31 March 2025

**DEVON MEADOWS/CASEY FIELDS SOUTH EMPLOYMENT PSP  
SUBMISSION ON BEHALF OF RAILWAY PROPERTY DEVELOPMENTS PTY LTD  
35 DEVON ROAD, DEVON MEADOWS (PSP PROPERTY: DM-27)**

**PROPOSED UPDATED PLACE BASED PLAN**  
35 DEVON ROAD, DEVON MEADOWS, Bunurong Country

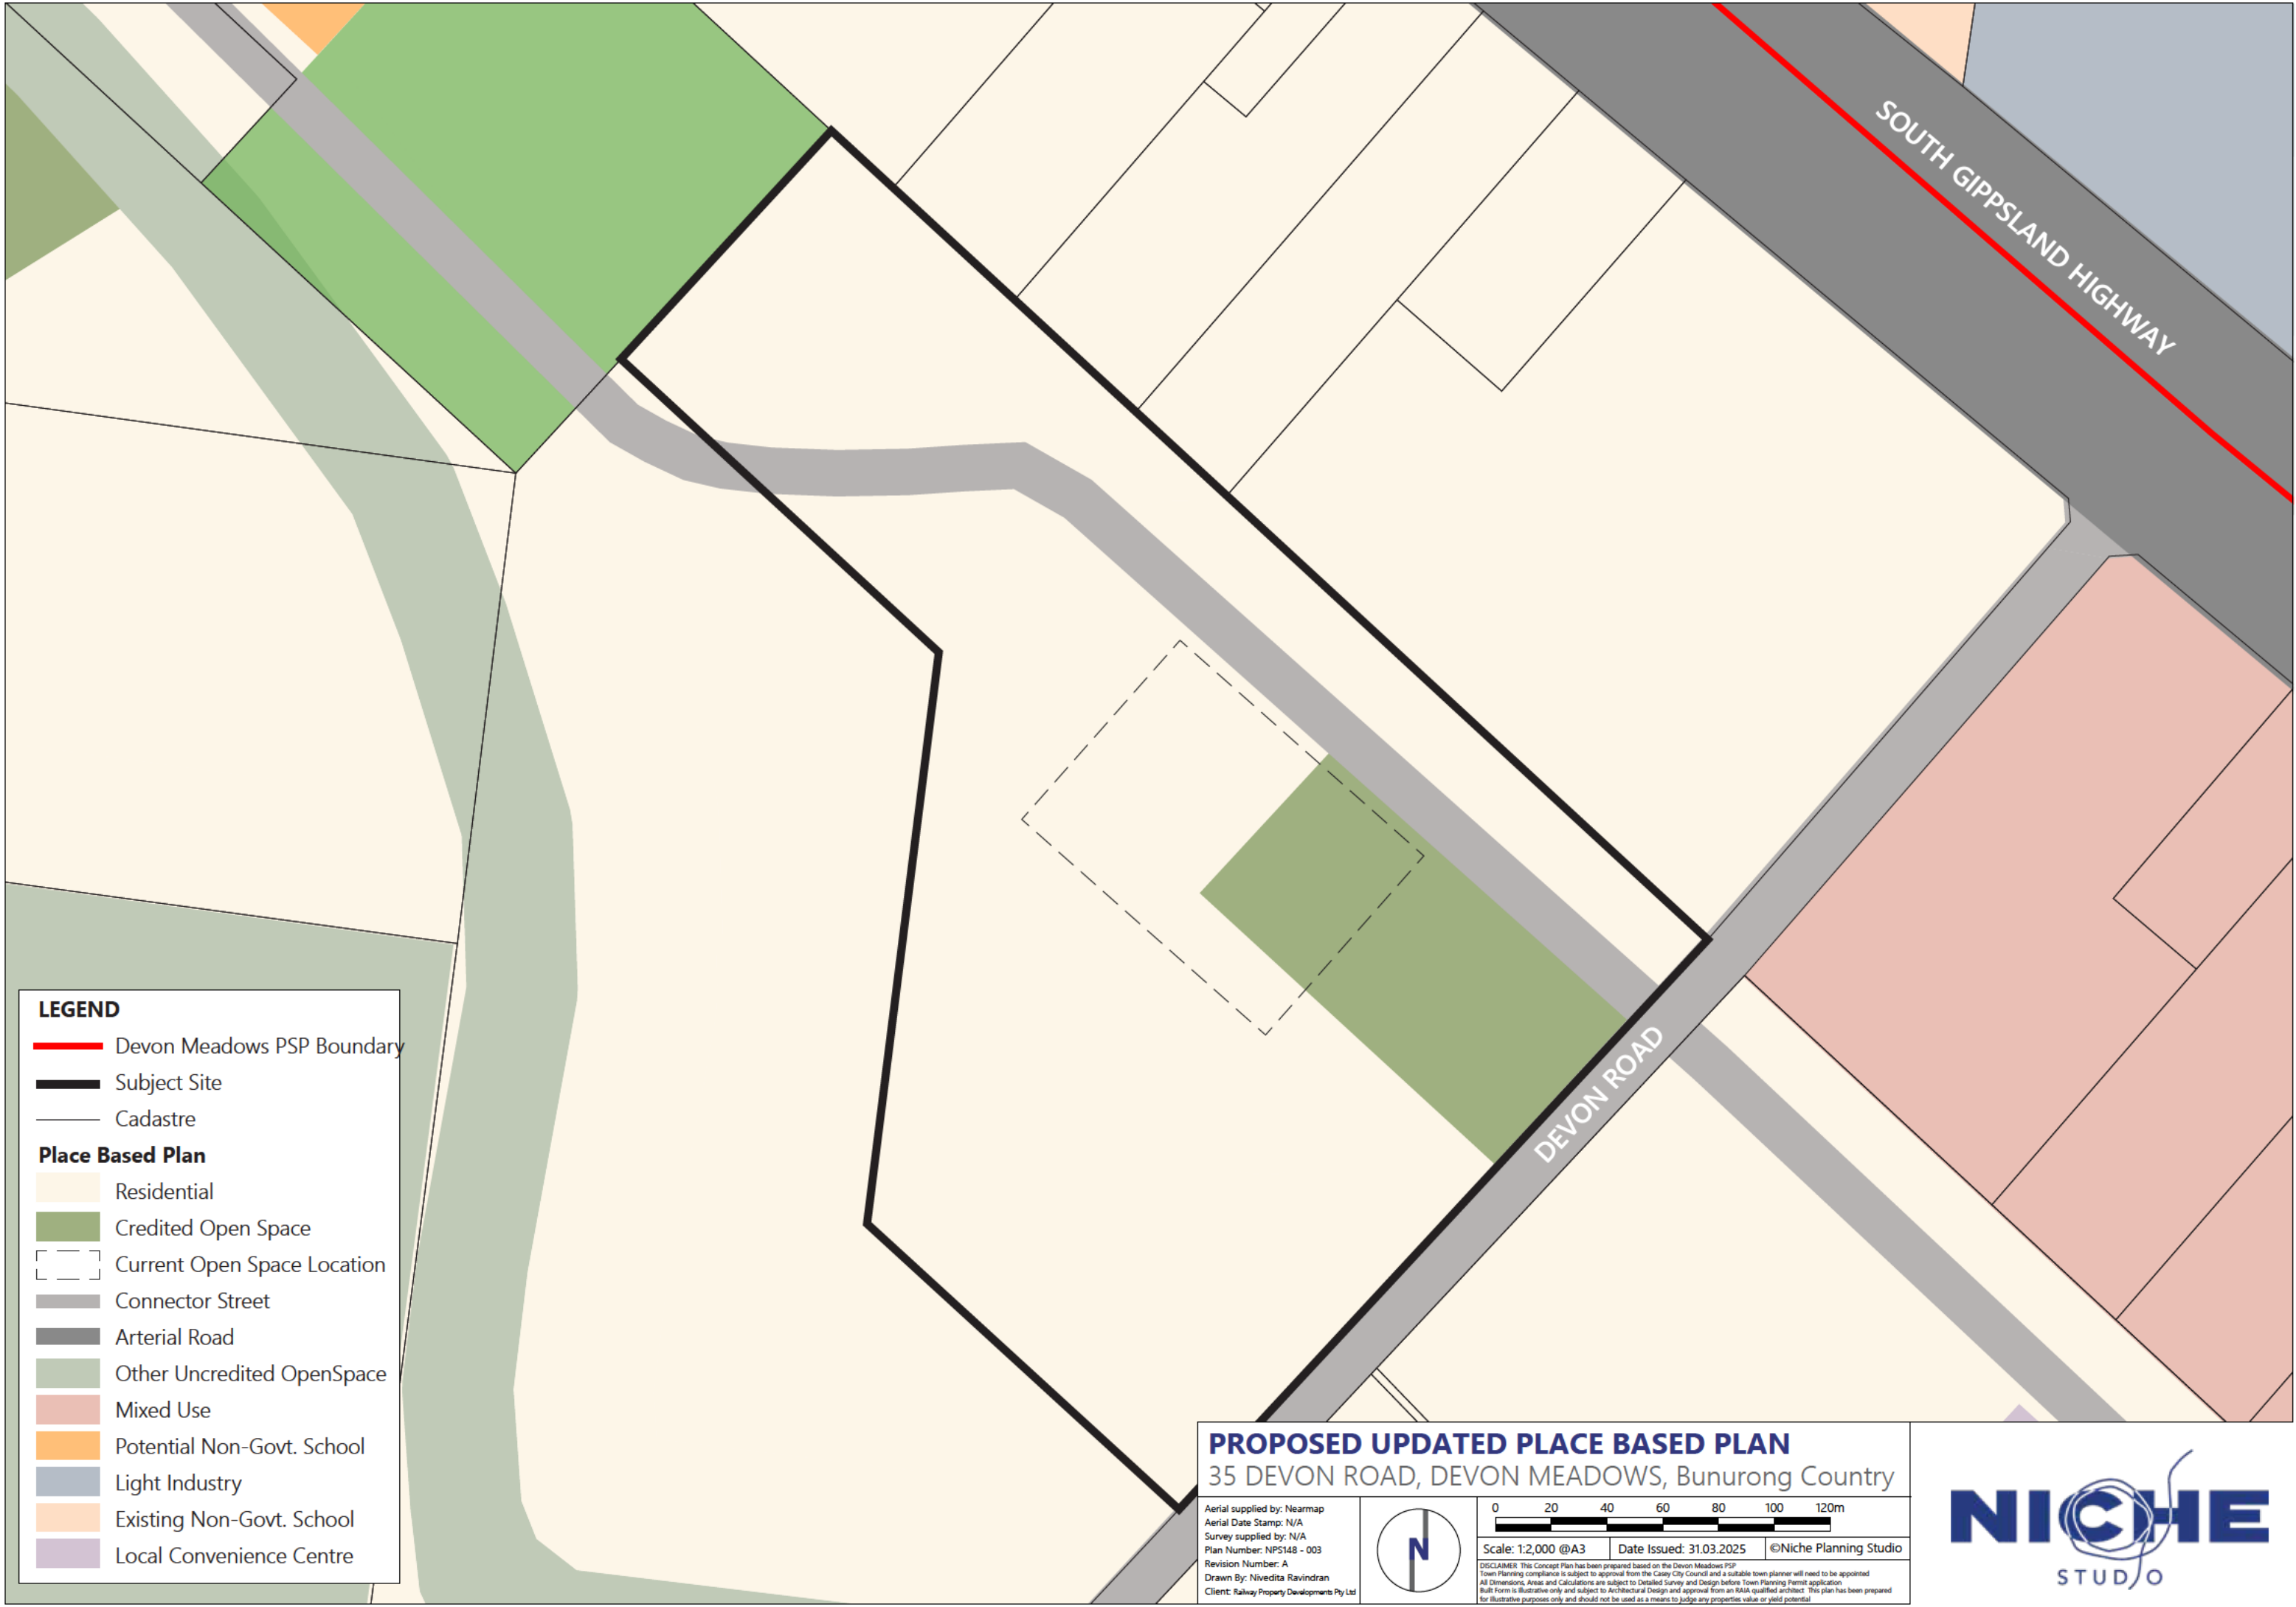
In reviewing the PSP, we support the designation of a 1ha Local Park (DM-LP-02) on the subject site, to allow for passive open space and amenity for future residents. However, we seek to relocate DM-LP-02 to the eastern boundary along Devon Road, to provide for an open space link close to the Mixed Use and Town Centre areas, as well as leveraging off the amenity of the existing native vegetation (discussed further in Item 2 below), which is required to be retained by Requirement 10 (R10) of the PSP.

We seek the same opportunity to retain vegetation within the local park afforded to DM-LP-02 to allow for the retention of some of the high-quality existing vegetation along Devon Road, incorporating this into the local park to allow for additional amenity opportunities.

- Relocate DM-LP-02 to the east along Devon Road, as per the attached plan (Attachment 1)
